TOWN COUNCIL COMMUNICATION

AGENDA ITEM: Discuss and consider a Final Plat for an approximate 32.029-acre property situated

in the J. Burke Survey, Abstract Number 42, in the Town of Bartonville, Denton County, Texas. The property is located near the southeastern corner of Broome Road and Porter Road, in Bartonville, Texas. The applicant is McAdams, Inc., on behalf of Philip R. and Martha S. Rice. [Town of Bartonville File Number FP-2025-002]. (The Planning & Zoning Commission recommended approval, with

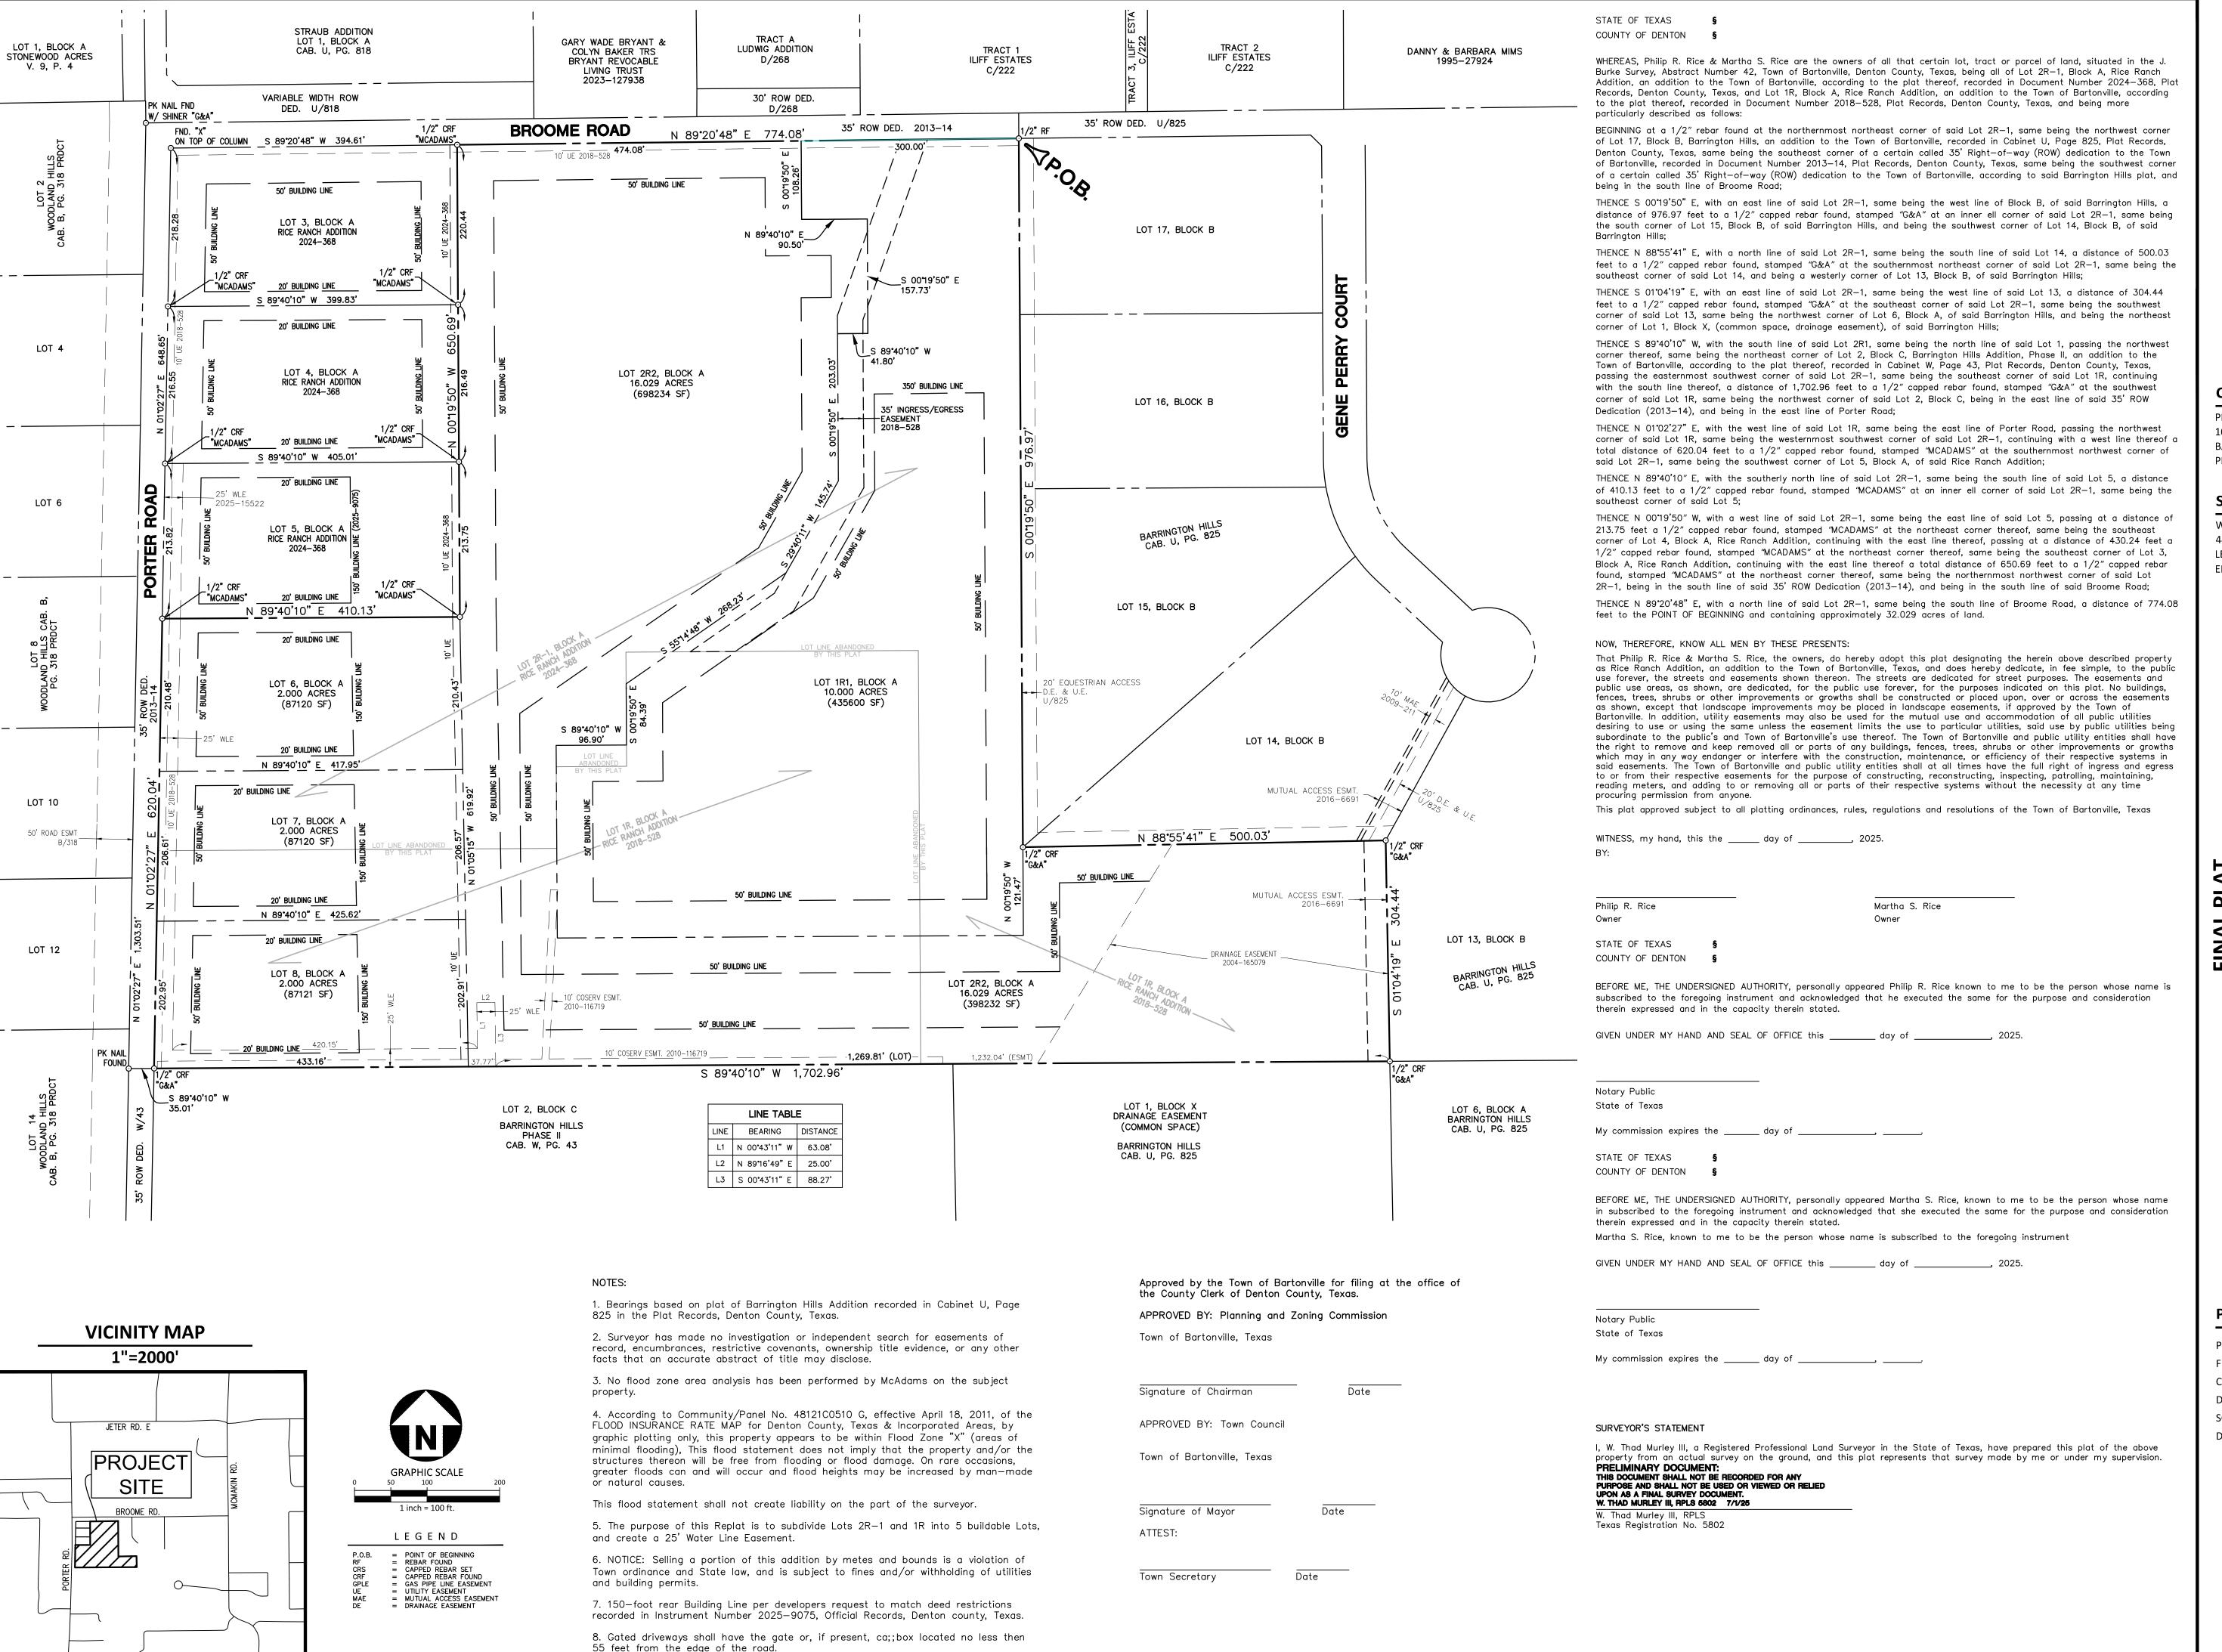
- 2. Prior to recordation of the final plat, the 25' water line easement (WLE) shall be labeled "25' WLE (BY THIS PLAT)". Basis: Town Code Chapter 10, Exhibit A, Development Ordinance Section 3.3.e.

- 3. Prior to the recordation of the final plat, the "30' GPLE 2010-86118" located within proposed Lot 6, Block A as shown in the approved Rice Ranch Minor Plat (MP-2024-003) shall be shown on the plat, unless documentation of the easement's vacation is provided to the Town. Basis: Scrivener's correction

- 4. Prior to recordation, the 25' WLE to be established by the plat shall be located to the east of the 30' GPLE along Porter Road. The water and gas line easement cannot overlap in parallel fashion. Basis: Town Code Chapter 10, Exhibit A, Development Ordinance Section 3.3.e.

- 5. Minor Correction: Note 8 shall read, "Gated driveways shall have the gate, or if present, callbox, located no less than 55 feet from the edge of the road." Basis: Scrivener's correction.
